## PROPOSED CHANGE NOTICE

2445-37

**RE:** AURORA FOOD STORE  
2000 ANAQUOD ROAD  
REGINA, SK  
Commission No. 2445

**RE:** CCTV Camera Locations

SHEET TITLE:  
FLOOR PLAN -  
SECURITY  
COMMISSION NUMBER:  
2445  
SHEET NUMBER:  
E6.0

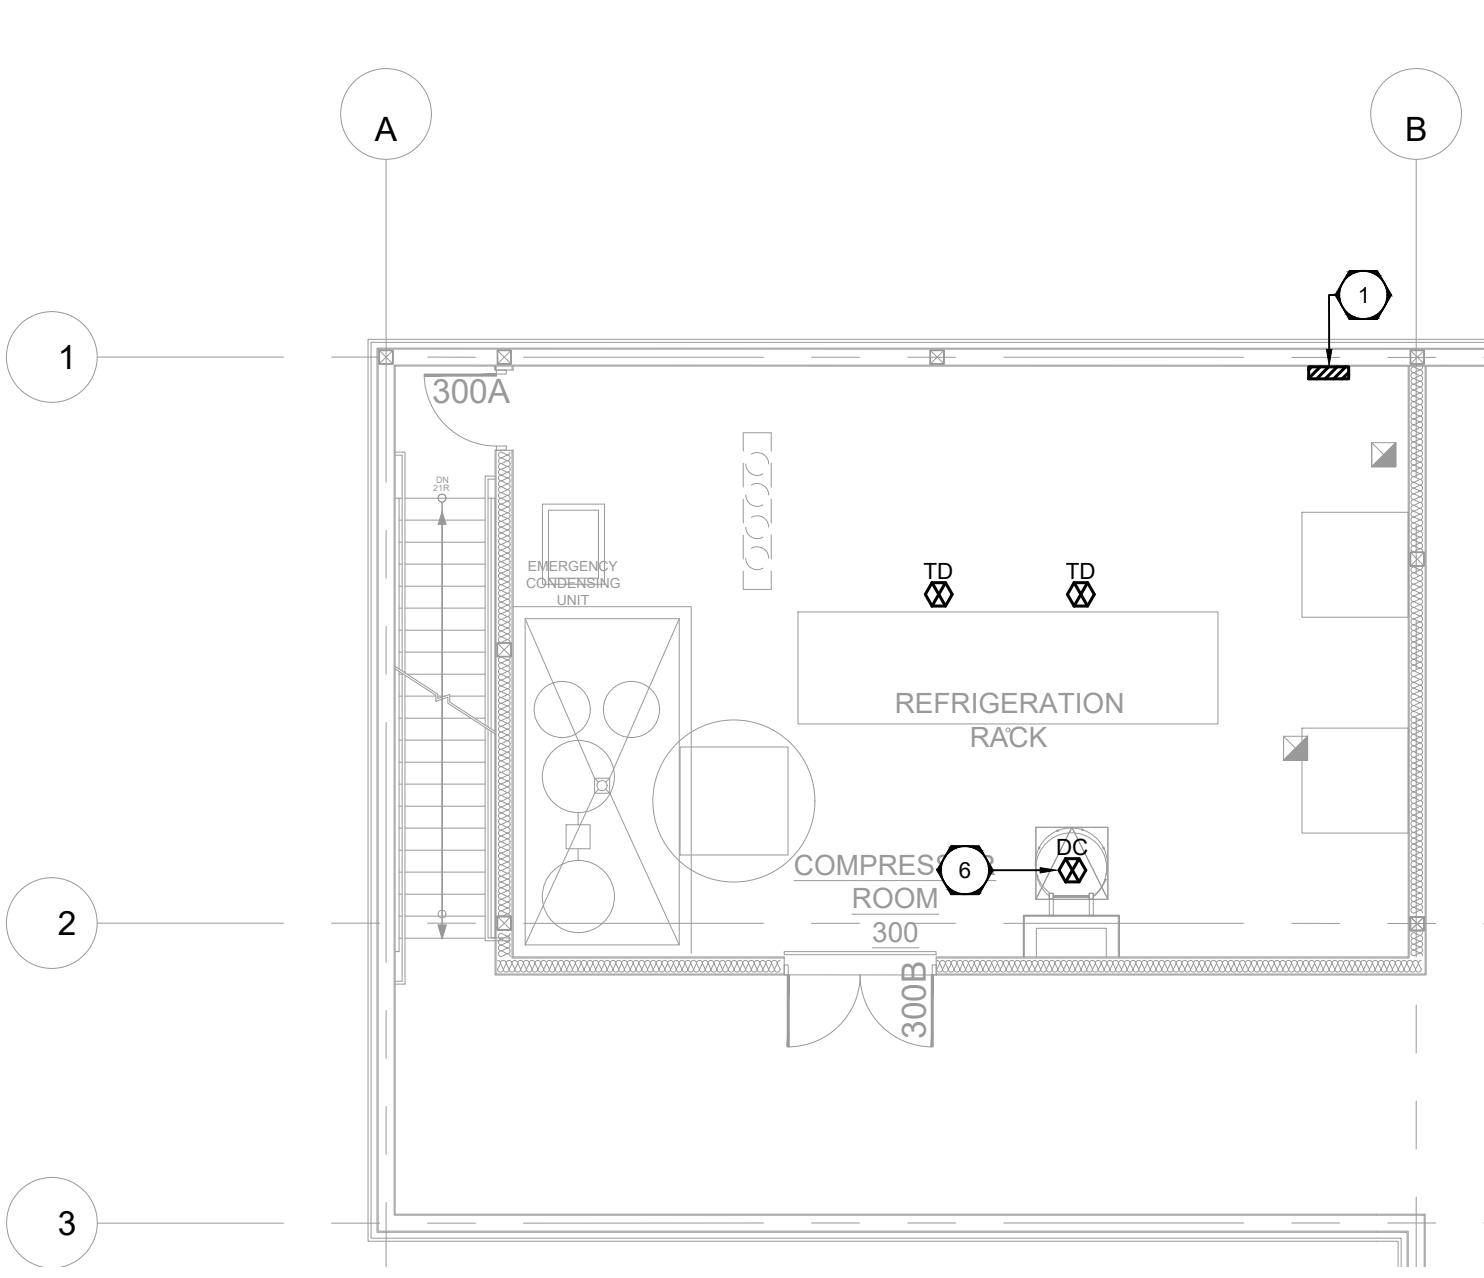
Subject: Revised CCTV Camera Layout  
References: Electrical Drawing E6.0 – Floor Plan - Security

1. Refer to attached drawing E6.0 for revised CCTV camera layout. Coordinate exact requirements with owner's security provider.
  - 1.1. An additional thirteen(13) camera locations are added on top of the original forty-one(41) camera locations.
2. Data cabling within sales area associated with the CCTV cameras will not be run in conduit. Provide credit to owner's for the removal of conduit from the scope of work within the sales area associated with the CCTV cameras.
